Modification of Minister's Approval

Section 75W of the *Environmental Planning & Assessment Act 1979*

Application Number:	MP10_0076
Proponent:	Sutherland & Associates
The Authority:	Minister for Planning
The Land:	Kirrawee Brick Pit, 566-594 Princes Highway, Kirrawee
Concept Approval:	Kirrawee Brick Pit Concept Plan granted on 23 August 2012 by the Planning Assessment Commission
Project:	Mixed use retail/commercial and residential development and associated public open space
Modification:	<p>MP 10_0076 MOD 3: modification includes:</p> <ul style="list-style-type: none">• 24,265m² increase of GFA (from 60,735m² to 85,000m²), comprising:<ul style="list-style-type: none">• 69,310m² of residential;• 14,190m² of retail/commercial (including 4,740m² supermarket and 1,450m² discount supermarket); and• 1,500m² community facility.• reduction of the total number of building envelopes from nine to seven and reconfiguration and amendment of building envelope locations, footprints, heights, separation distances and setbacks;• amended construction staging and timing of the delivery of the open space; and• removal of the car parking cap and imposition of car parking rates.

The Concept Plan for

STIF Impacts Comparison

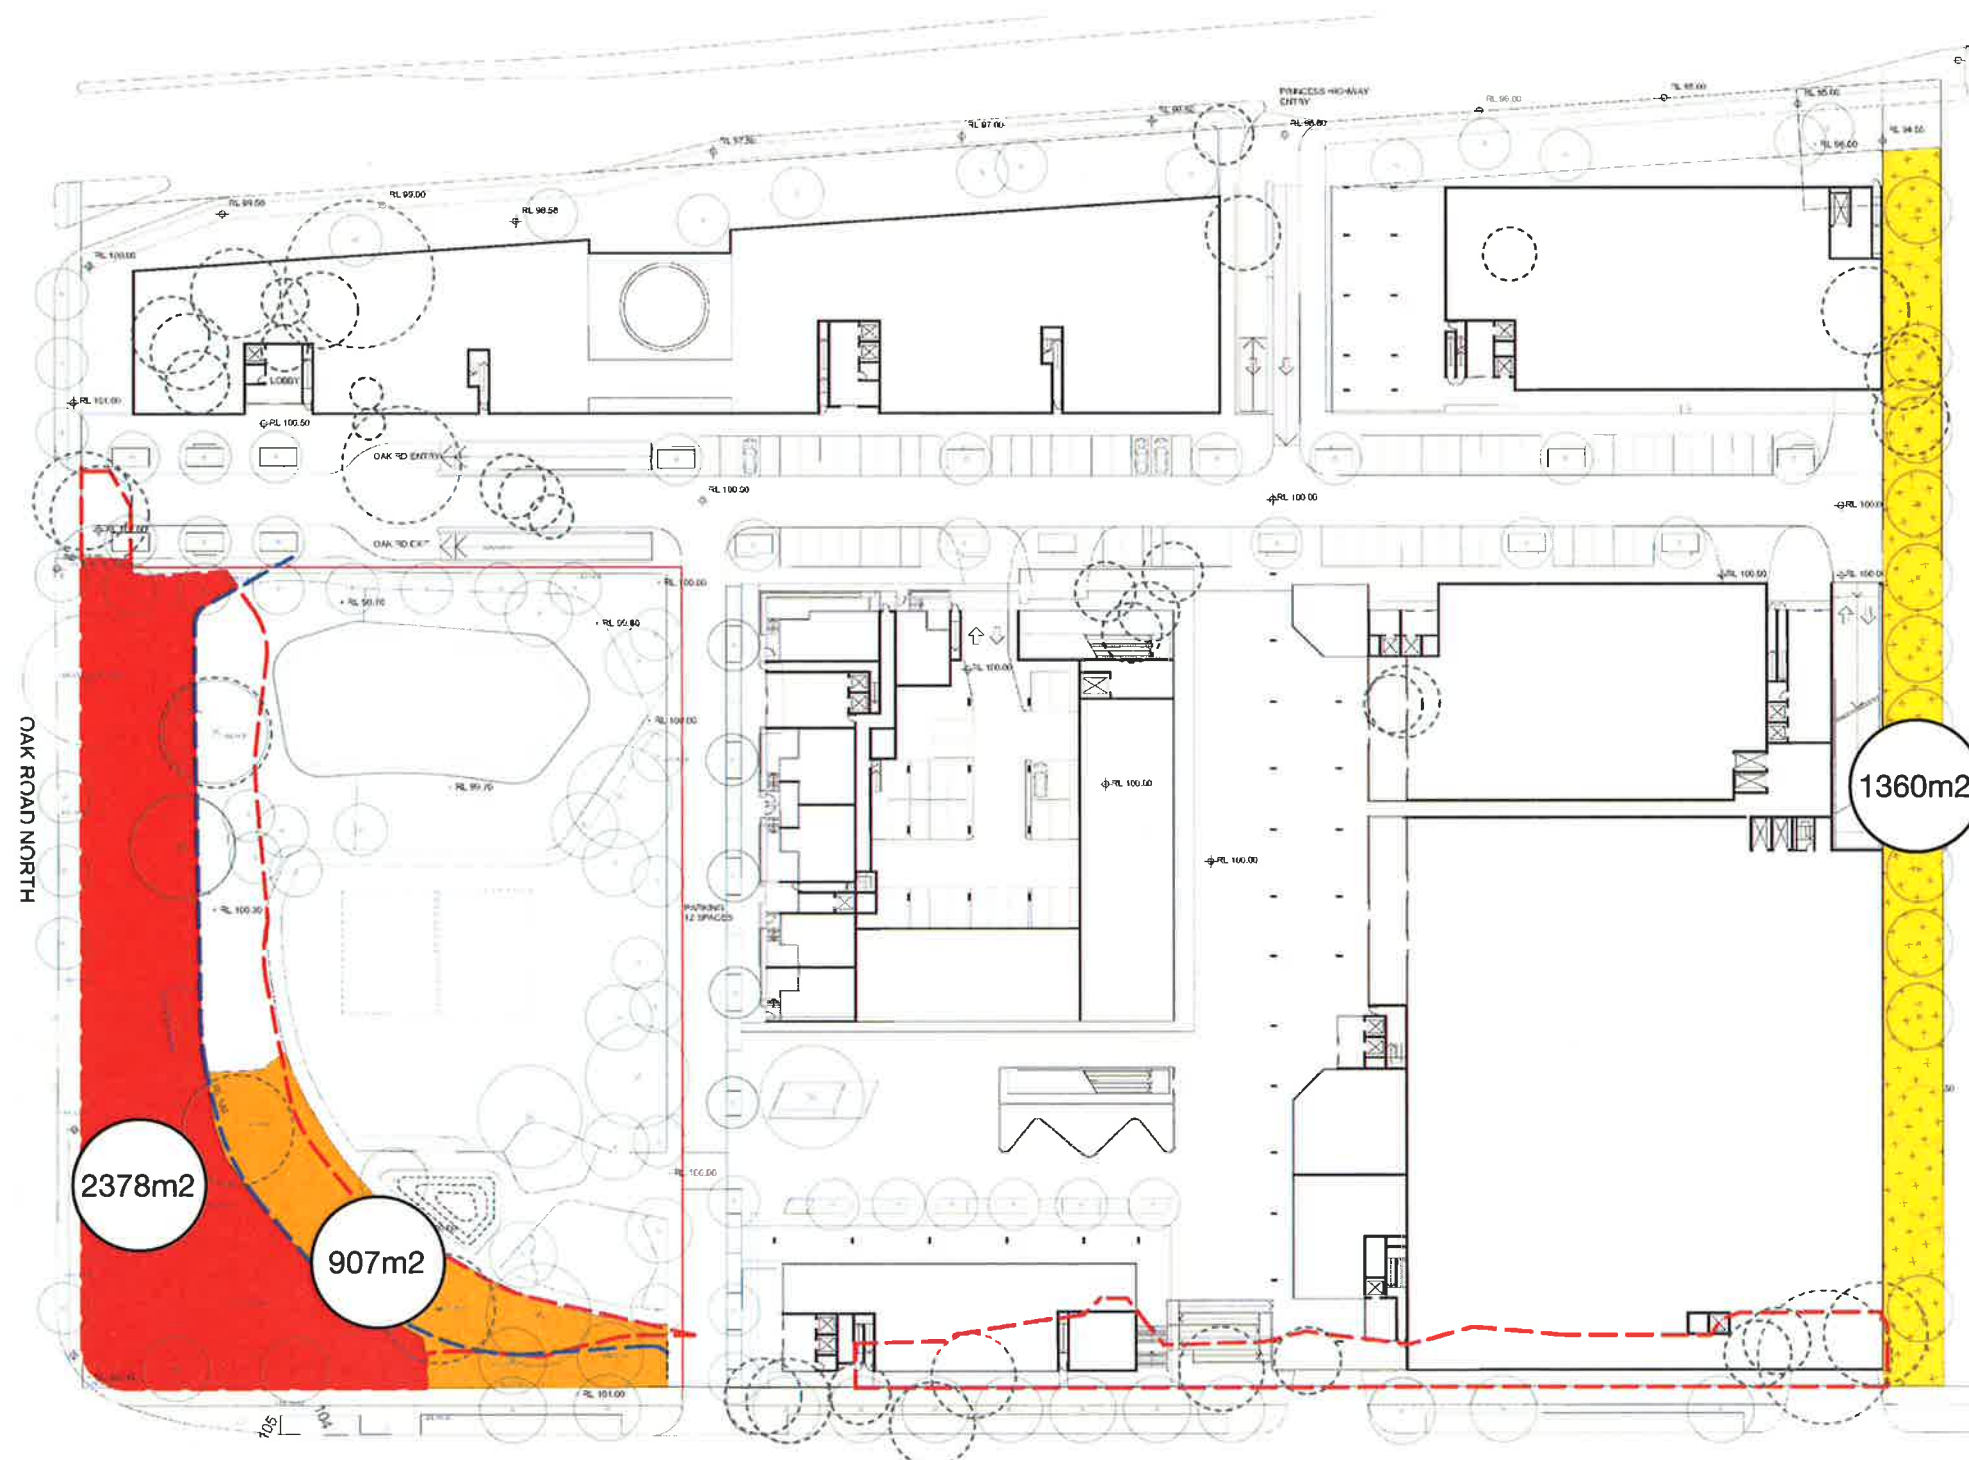
- a) Be designed by a qualified landscape architect and generally in accordance with the plans and documents referred to in Condition A2; and in consultation with the Council;
- b) Include a lake, which can be located as shown on Drawing 13066-S75W07B (dated August 2014) or in a location agreed by Council;
- c) Provide for the conservation of the Sydney Turpentine Ironbark Forest; and
- d) Be publicly accessible; ~~and~~
- e) Include high quality hard and soft landscaping and paving areas and a variety of recreation facilities;
- f) Be contiguous with and accessible from the public domain
- g) Include a Vegetation Management Plan that is consistent with NSW Office of Water's Guidelines for vegetation plans on waterfront land; and
- h) include future management requirement and an implementation program.
